**MEMORANDUM**

REVIEW TYPE: **Site Plan Review**  
 CASE #: **8-04026**  
 PROJECT NAME: **Giancola Quarry**  
 APPLYING FOR: Approval of 15 one-family detached homes and 15 townhouses, including 18 Transfer Development Rights

ZONE: R-200/TDR-8  
 LOCATION: In the northeastern quadrant of the intersection of River Road (MD 190) and Old Seven Locks Roads  
 MASTER PLAN: Potomac Subregion  
 APPLICANT: Giancola Quarry  
 FILING DATE: March 2, 2004  
 HEARING DATE: July 22, 2004

### Intersection Improvement at River Road (MD 190) and Seven Locks Road

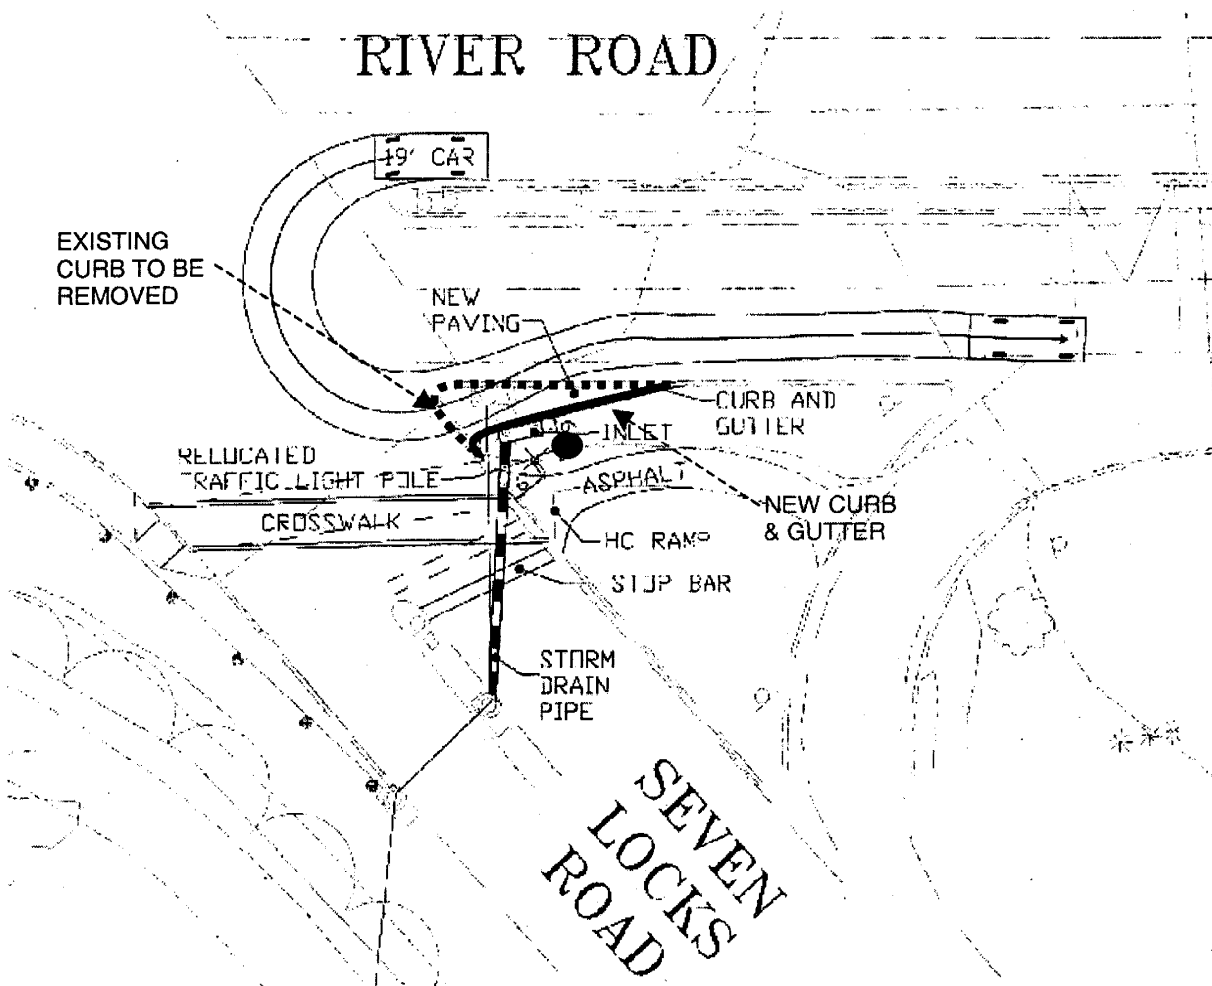
During the Planning Board's review of the preliminary plan, there was an issue raised by the citizens regarding the existing geometric conditions at the intersection of River Road and Seven Locks Road to accommodate U-turn movements safely from westbound River Road (see vicinity and site maps on pages 6 and 7).

In order to address this issue, the applicant proposed the intersection improvement as shown on the drawing below. The improvement will modify the traffic island in the southeastern quadrant of the intersection, including relocating a traffic signal pole, at a cost estimated to be between \$90,000 and \$100,000. This improvement will provide an adequate turning radius for the safe U-turn movement of passenger cars.

Based on the traffic evaluation submitted by the applicant's traffic consultant, the amount of truck traffic associated with the proposed residential development, totaling up to five trucks per day, will be significantly less than the amount of the truck traffic associated with the current quarry activities. One observation of the existing truck activity showed 17 trucks during a one-hour period in the morning. Thus, staff finds that construction of the intersection improvement proposed by the applicant in connection with the subject site plan is adequate to address this traffic safety issue associated with westbound U-turn movements on River Road at Seven Locks Road.

- a. Total development under the subject site plan is limited to 30 dwelling units (15 townhouses and 15 one-family detached).
- b. The applicant shall provide the physical intersection improvement as shown on the approved site plan to accommodate safe passenger car U-turn movements from westbound on River Road at Seven Locks Road. This improvement shall be completed prior to occupancy of the second dwelling unit.
- c. The applicant shall construct one right-in right-out entrance driveway on River Road, and an eight-foot-wide shared use path (Class I bikeway) along River Road from the entrance driveway westward to Seven Locks Road as shown on the site plan, subject to State Highway Administration's review and approval.
